To: Elle Donnelly
From: David Richards
Subject: J17300 - New England Solar Farm - Information request

This memorandum provides a consolidated response to DPIE's request for additional information (dated 5 December 2019). A set of updated project figures is provided in Appendix A.

Assessed viewpoints, sensitive receptors and project refinements

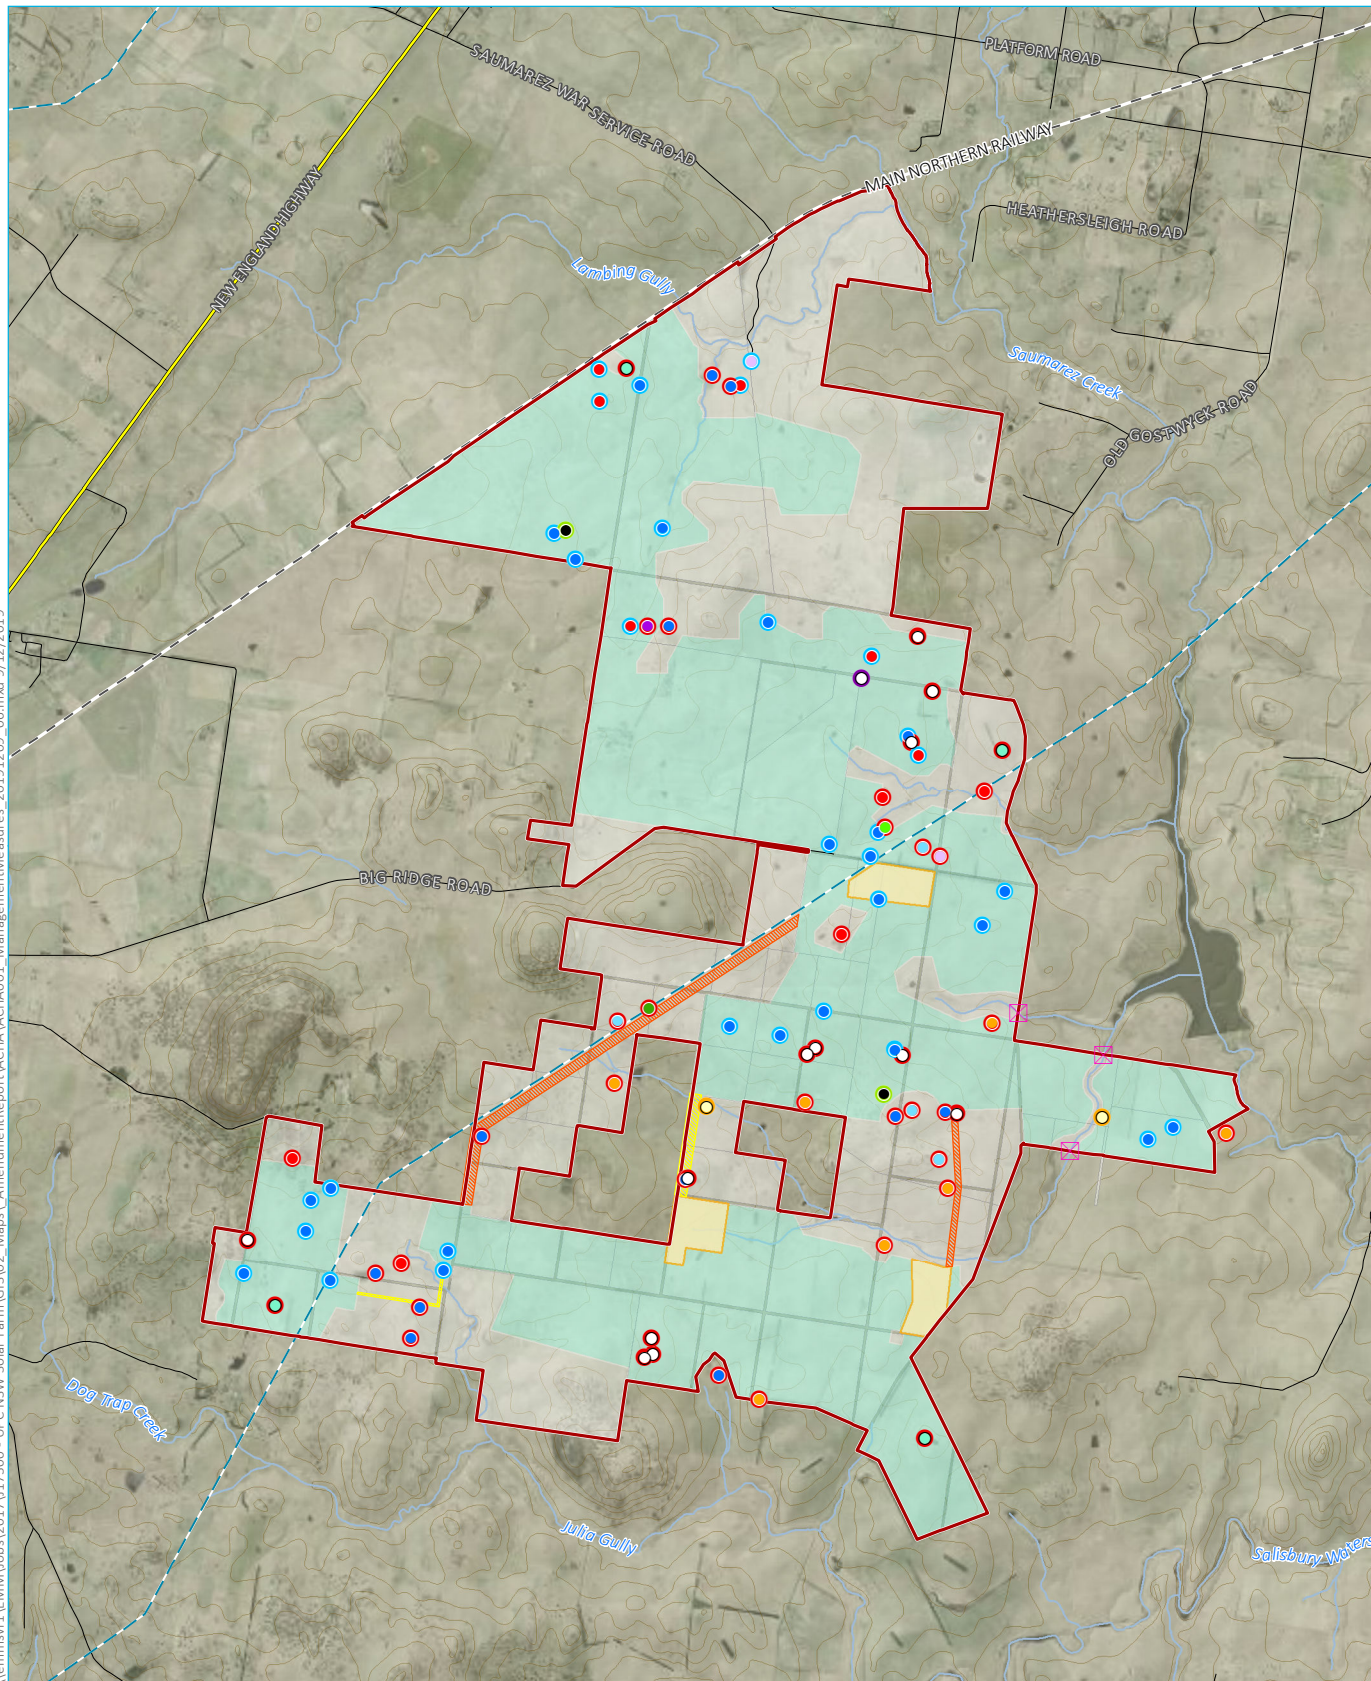
- Project impacts to identified heritage values – updated to include areas where security fencing will cross third order watercourses;
- Assessed viewpoints, sensitive receptors and project refinements – updated to include areas where security fencing will cross third order watercourses; and
